Selected Non-Proprietary  
Correspondence from Boeing to Captain S. Kelada and Engr. Hamdy of EgyptAir

Split Elevator Failure Scenarios  
Effect of High Rate Column Inputs  
Dynamic Analysis  
Autopilot Disconnects on DFDR  
Action Items

9 June 2000 thru 15 December 2000

Subject: Split Elevator Failure Scenarios - Egyptair 767-300ER SU-GAP,  
Accident Off Nantucket, Massachusetts – 31 October, 1999

PAGE  
Figure 1

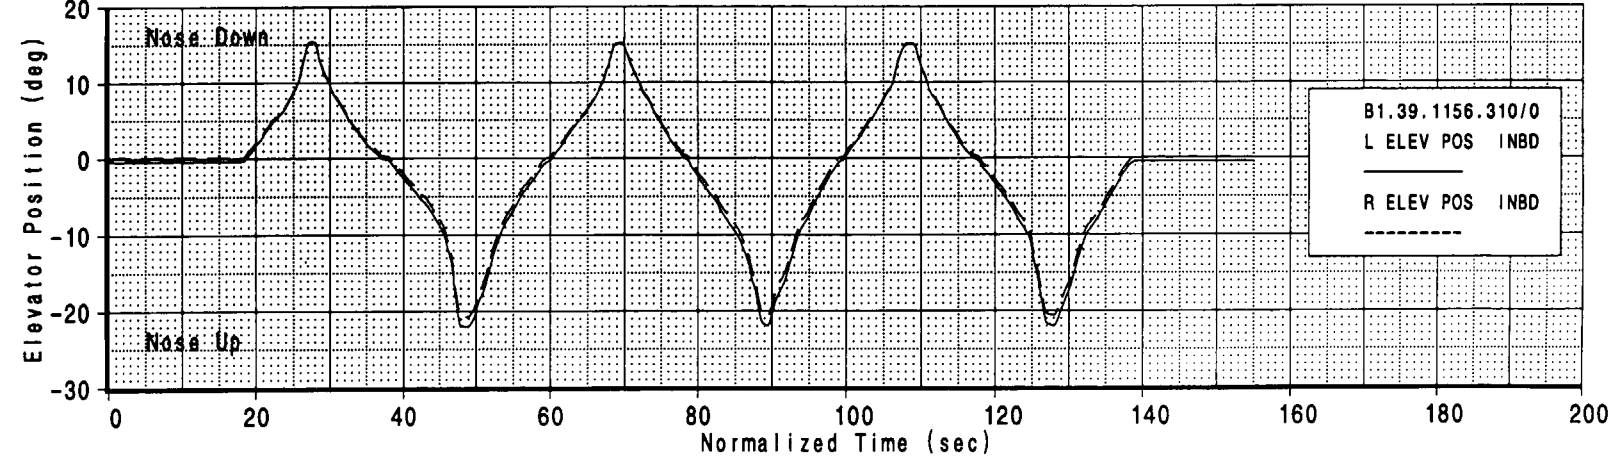
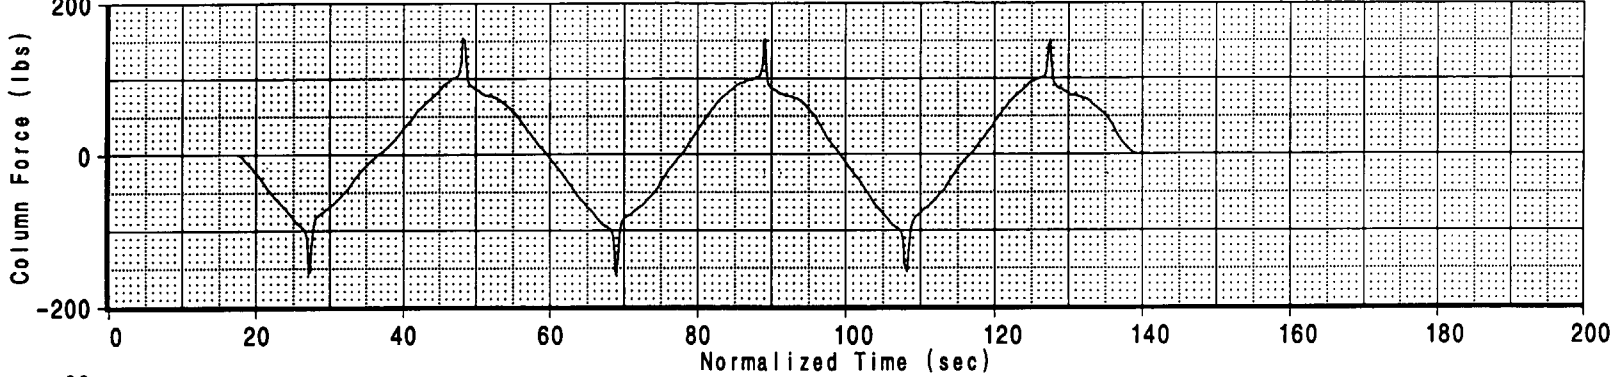
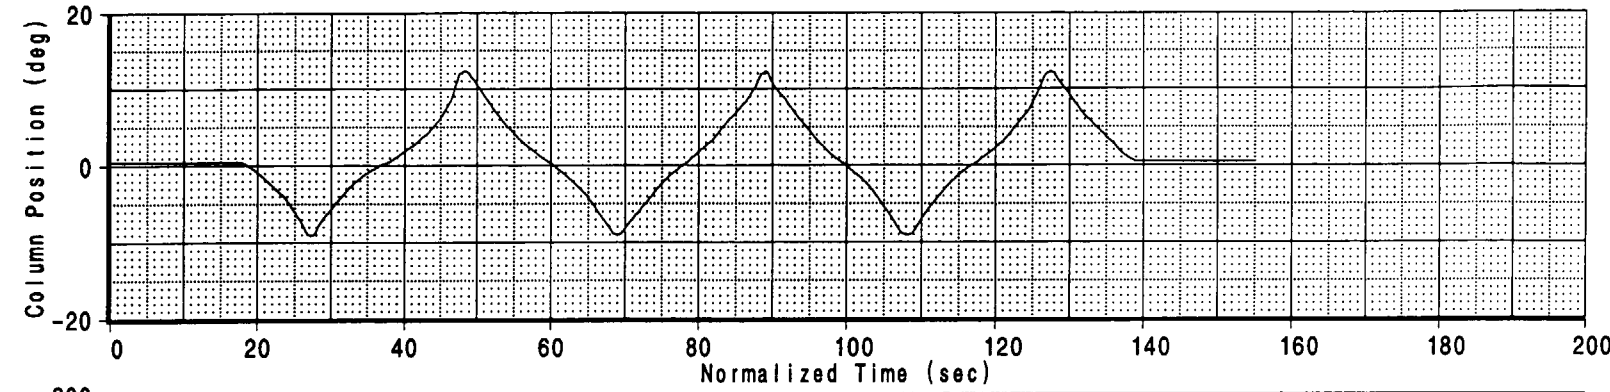
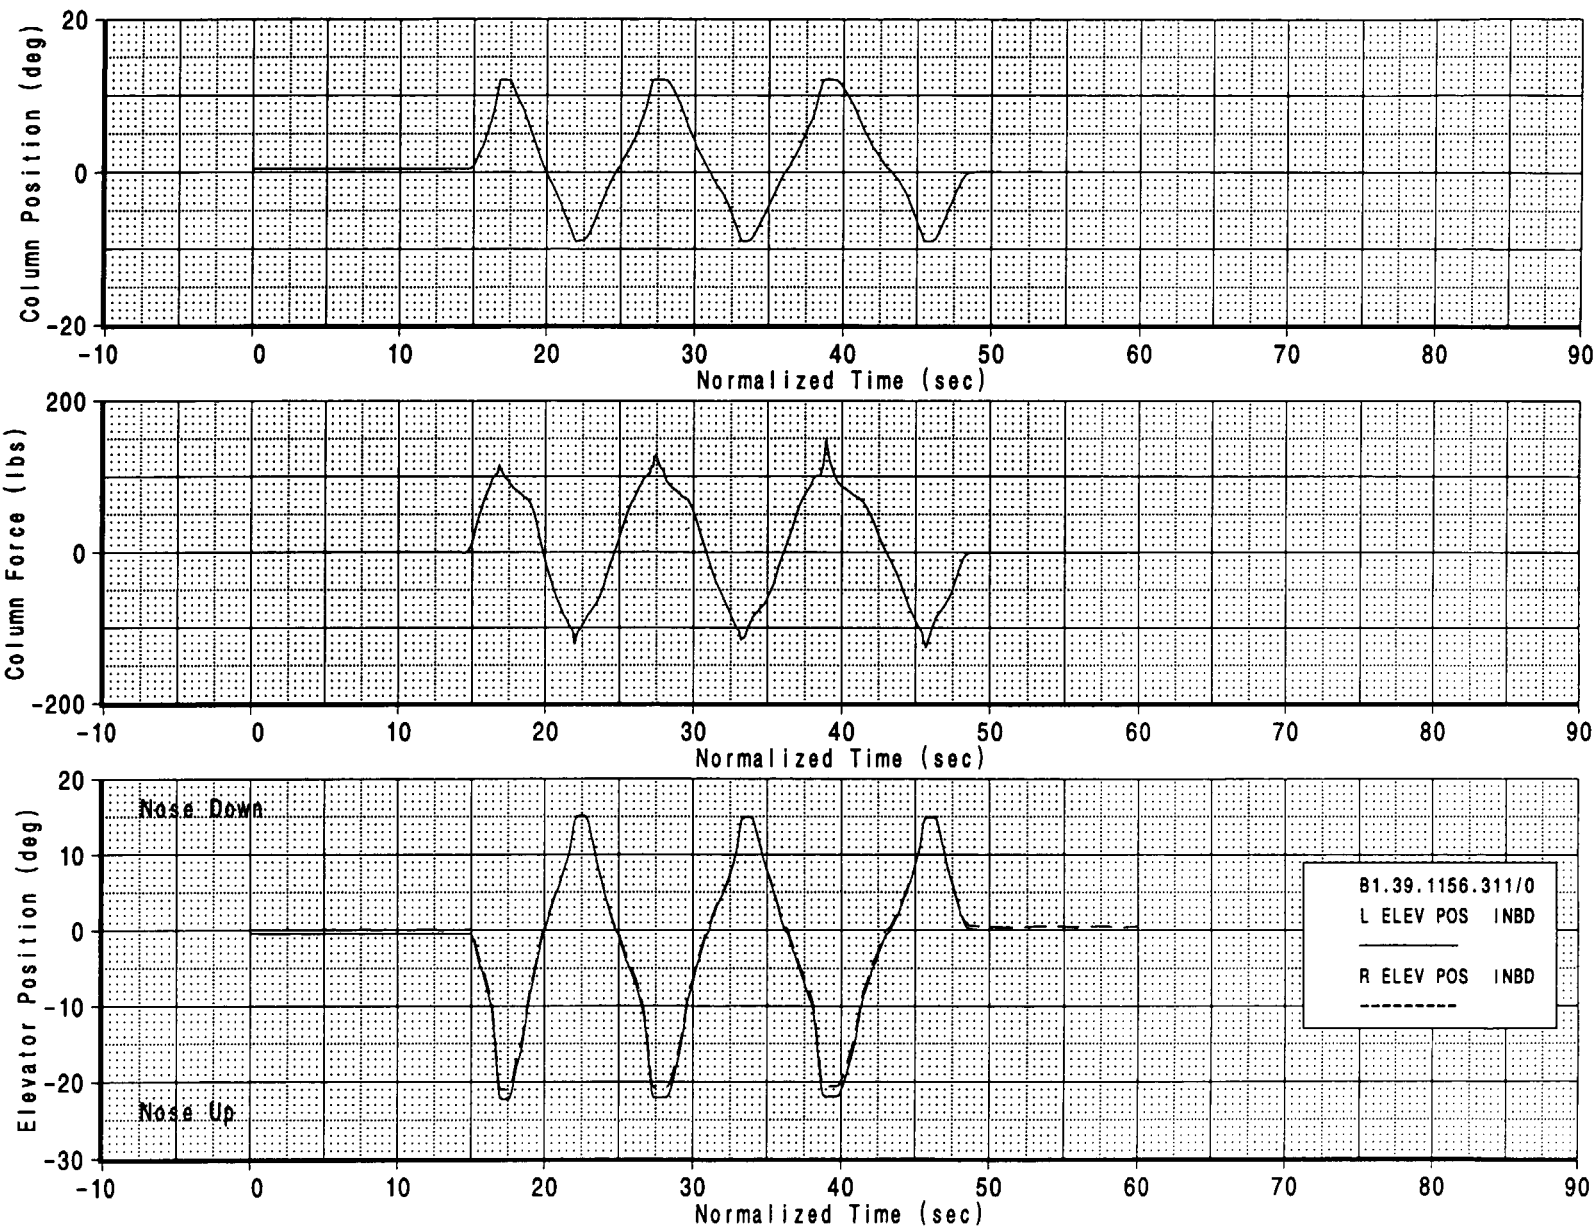
Further to the reference e-mail, the Egyptian Delegation (ED) requested that Boeing provide a description of the effect of a rapid control column pull from the right seat during the flight 990 descent conditions.

A slightly higher column force is required to obtain the same elevator deflection when the column is experiencing rapid pull motion. This slight increase in column force increases with rate and acts as a resistive damping force in the elevator control system. This damping effect is best demonstrated using aircraft test data. The effect of column rates on the elevator system was measured during a ground test on the same 767-400 aircraft utilized for the dual PCA failure demonstrations, VQ001. For this ground test, the elevator feel pressure was set to 900 psi and three column sweeps were conducted at three different rates. Figure 1 presents time history data of the elevator system for three slow rate column sweeps that were conducted over the course of 120 seconds. Figure 2 presents time history data of the elevator system for three medium rate column sweeps that were conducted over the course of about 33 seconds. Figure 3 presents time history data of the elevator system for three high rate column sweeps that conducted over the course of about 18 seconds. The time histories of figures 1, 2, and 3 show that the tracking of the two elevators is not affected by the rate of column input. In all cases, the two elevators track just as well dynamically as they did statically. The slight increase in column force with column rate is difficult to see from the time history data. Cross-plots of column force versus elevator position are ideal for showing the increase in column force with column rate. Figure 4 shows a cross-plot of the column force versus elevator position for the slow rate column sweeps (solid lines) and the medium rate column sweeps (dashed lines). Figure 4 shows that the medium rate column sweeps have a larger force hysteresis than the slow rate column sweeps. This

increase in force hysteresis is caused by damping forces in the elevator control system, which resist increases in column rate. Pulling the control column aft of zero at a medium rate took about 2 to 5 pounds of additional column force relative to the slow column sweeps in order to achieve the same elevator deflection. Figure 5 shows a cross-plot of the column force versus elevator position for the slow rate column sweeps (solid lines) and the high rate column sweeps (dashed lines). Figure 5 shows that the high rate column sweeps have an even larger force hysteresis than was present during either the slow rate or medium rate column sweeps. Pulling the control column aft zero at a high rate took about 5 to 10 pounds of additional column force relative to the slow sweep in order to achieve the same elevator deflection.

Figure 1

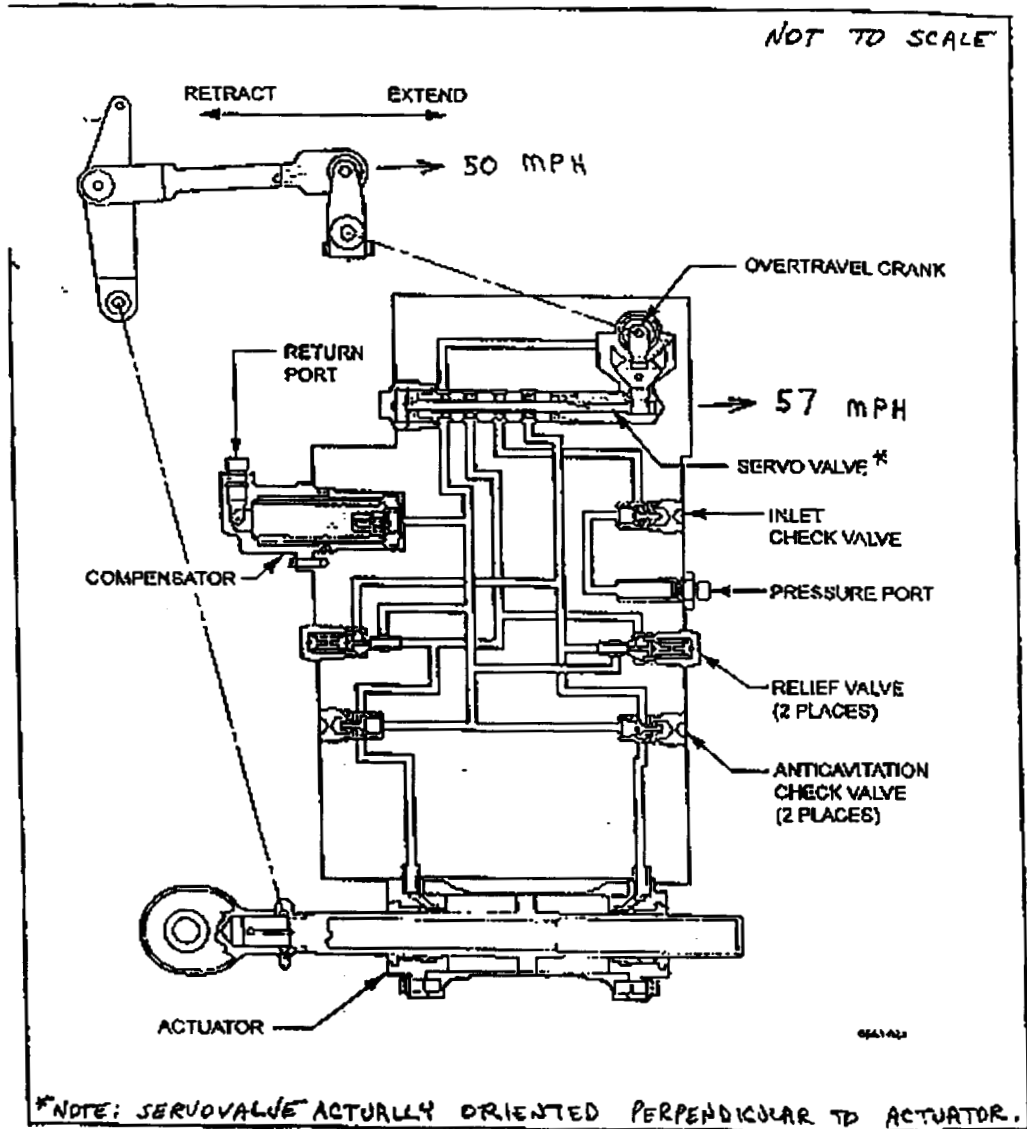
Boeing to provide a dynamic analysis (with supporting rationale) to explain the condition of the servovalve of Elevator PCA #3 as documented in the Boeing EQA and the NTSB Materials Laboratory portions of the factual report.

During the accident impact, system/structural buckling and/or the inertia of the external elevator PCA linkages and pogo provided an extremely rapid extend input to the servovalve slide (see attached Figure 1). The accelerations involved caused a mismatch of the spring to the spring guide (this acceleration has not been directly calculated). Once the internal linkage reached the overtravel region, the item 355 overtravel cam, item 315 servo slide, and item 310 spring guide continued to travel in the extend direction until the item 355 overtravel cam “bottomed” against the manifold (see attached Figure 2, positions 1 and 2). When the item 355 overtravel cam and item 325 servo slide “bottomed” (and would have even “bounced back”), the inertia of the item 310 spring guide provided enough energy to shear the item 305 pin (see attached Figure 2, position 3). The velocity necessary for sufficient spring guide inertia to shear the pin is calculated to be ~57 mph (see attached calculations, note that the spring mass was not included). Subsequently, the item 315 spring pushed the item 310 spring guide off the end of the item 325 servo slide. The item 310 spring guide was then unconstrained and could move off center relative to the item 325 servo slide. Subsequent retract input commands from the external linkage (either during impact or during recovery or subsequent mishandling), would force the end of the item 325 servo slide against the item 310 spring guide. The off-center contact would result in the item 310 spring guide and the mismatched item 315 spring being “scraped” along the inner side and end of the item 290 servo cap. This “scraping” resulted in partial removal of the anodize layer on the item 290 servo cap and resulted in the observed corrosion (after submersion in salt water and subsequent exposure to air).

Figure 1

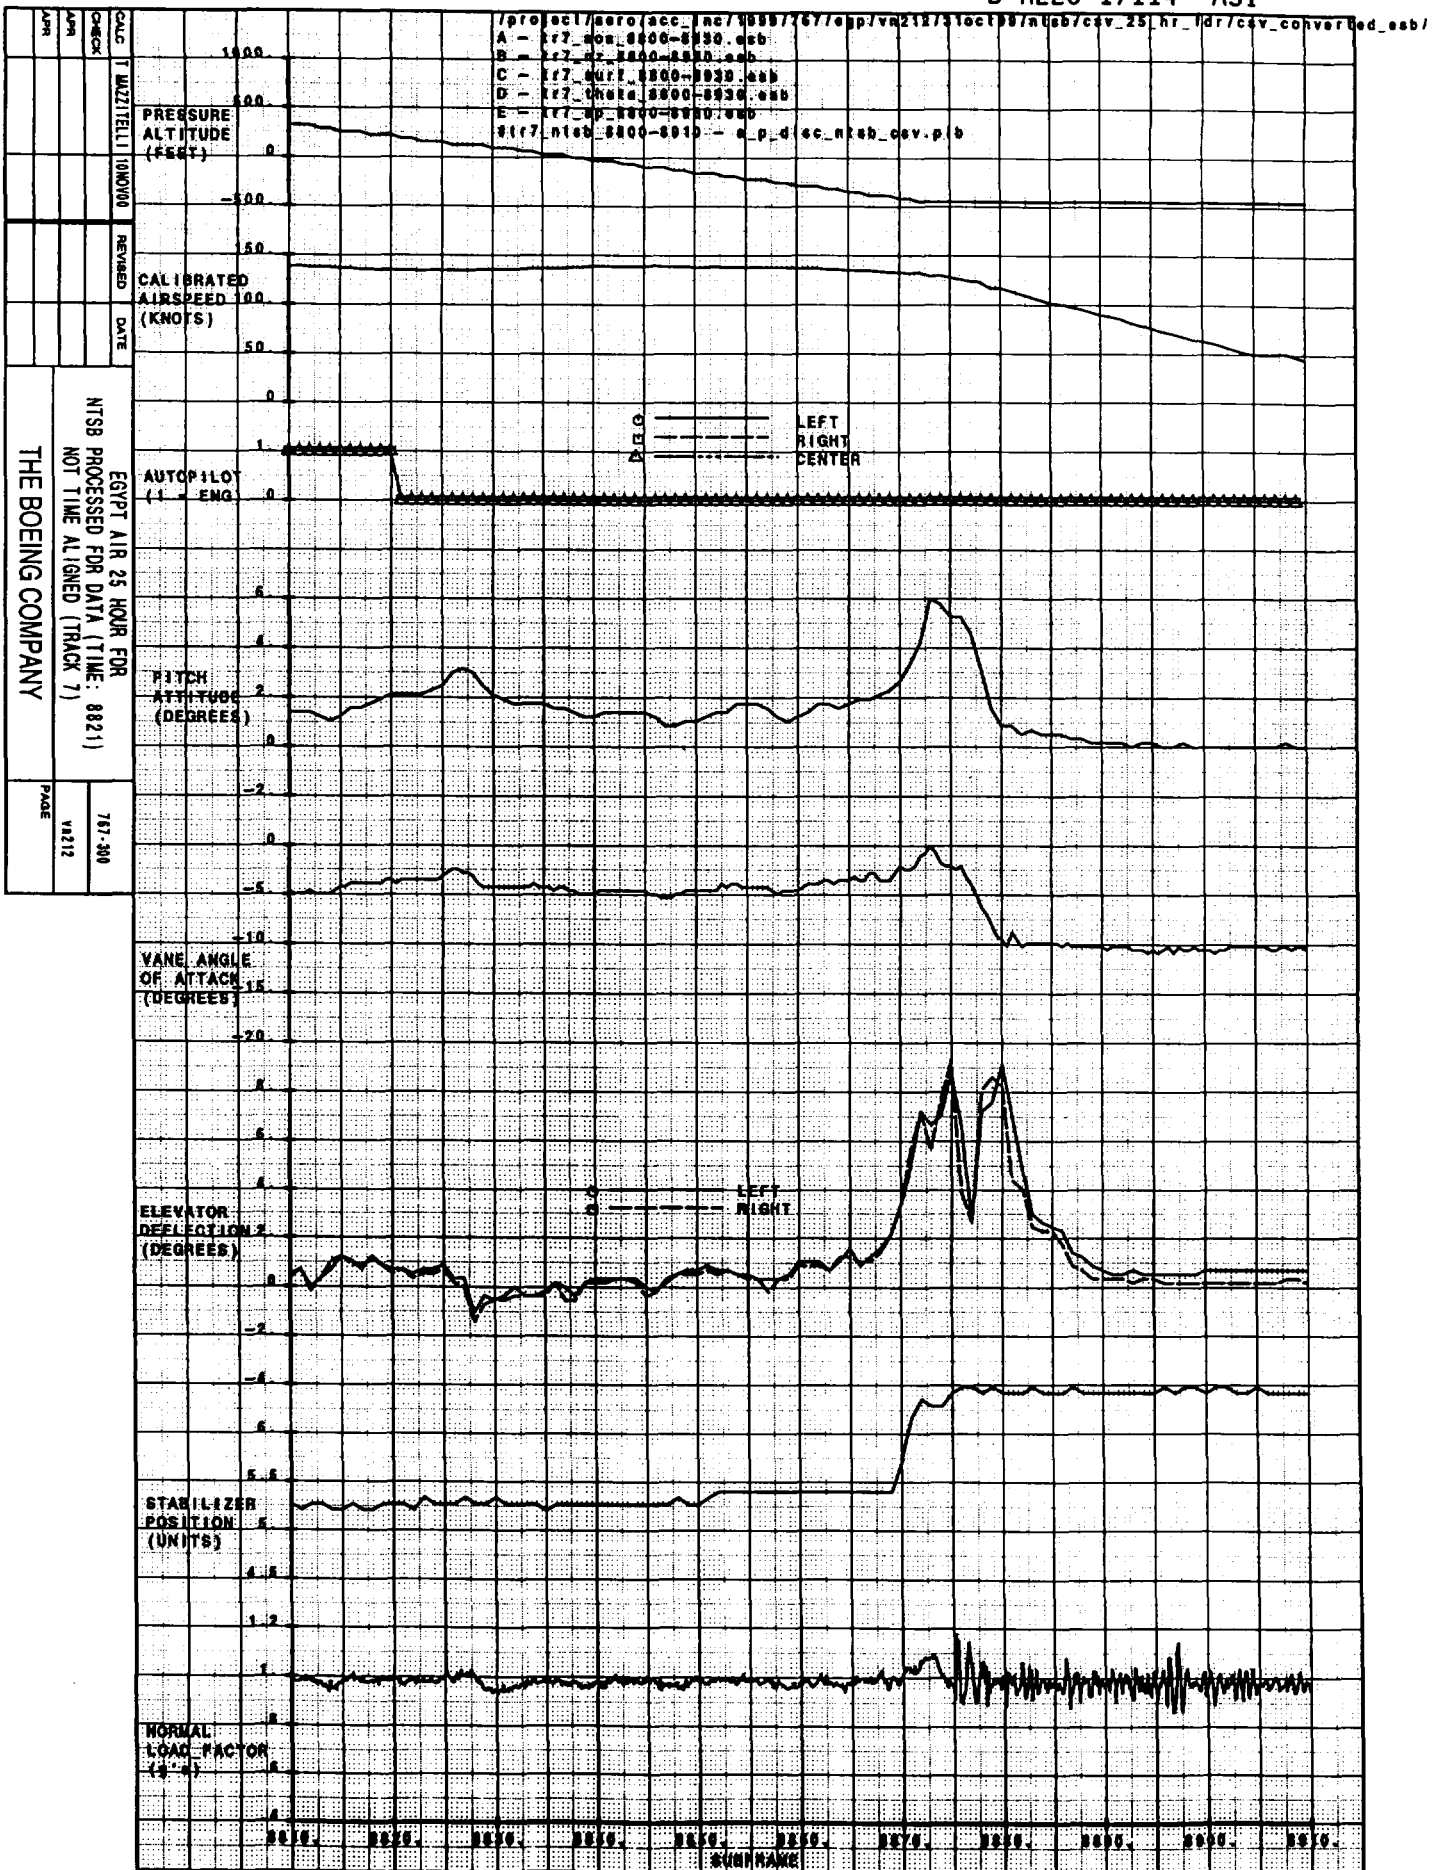
As requested by the Egyptian Delegation (ED) in reference (a), the ED asked Boeing to review the small elevator surface deflection downward and asymmetric elevator surface motion which occurred immediately after the autopilot disconnects recorded on the digital flight data recorder (DFDR) of the subject airplane. Also in reference (b), you requested three additional items: 1) data plots for all autopilot disconnect events, 2) FDR track and sub-frame number for each autopilot disconnect event, and 3) resolve a concern regarding missing data on figure 2.

Figure 1 presents the DFDR data from an autopilot disconnect which occurred just prior to a landing. The triple channel autopilot was disconnected at sub-frame of 8821 in figure 1.

In the seven seconds (sub-frames) prior to the autopilot disconnect in figure 1, the tracking of the two elevators is excellent with a tracking difference of 0 to 0.17 degrees (0 to 1 LSB) and average deflection of about 1 degree of nose up elevator.

In the 60-second period following the autopilot disconnect in figure 1 (up until the landing flare maneuver at a sub-frame of 8880), the tracking of the two elevators remains excellent with the tracking difference mainly in the range of 0 to 0.35 degrees (0 to 2 LSBs). The act of disconnecting the autopilot in figure 1 may have increased the elevator tracking difference by about 0.17 degrees (1 LSB). In the three-second period following the autopilot disconnect in figure 1, the average elevator position moves slightly in the nose up direction. Since this autopilot disconnect occurred close to the ground and there was a fair amount of elevator activity, pilot forces were certainly present for most if not all of this 60-second period. The presence of pilot forces during this period makes it hard to say whether the small shifts in the elevator

An interesting feature in figure 1 is how the elevator tracking difference changed as the pilot returned the controls to neutral after the landing flare maneuver. When the elevators settle out at neutral (the sub-frames beyond 8896), the elevator tracking difference has increased to about 0.52 to 0.70 degrees (3 to 4 LSBs) with the right elevator more nose down than the left elevator. This elevator tracking is worse than when autopilot or pilot forces were present, but it appears to be a stable configuration for the no-load elevator control system. The elevator control system's no-load characteristics are influenced by the aspects of the mechanical installations described earlier and the flight control rigging process.
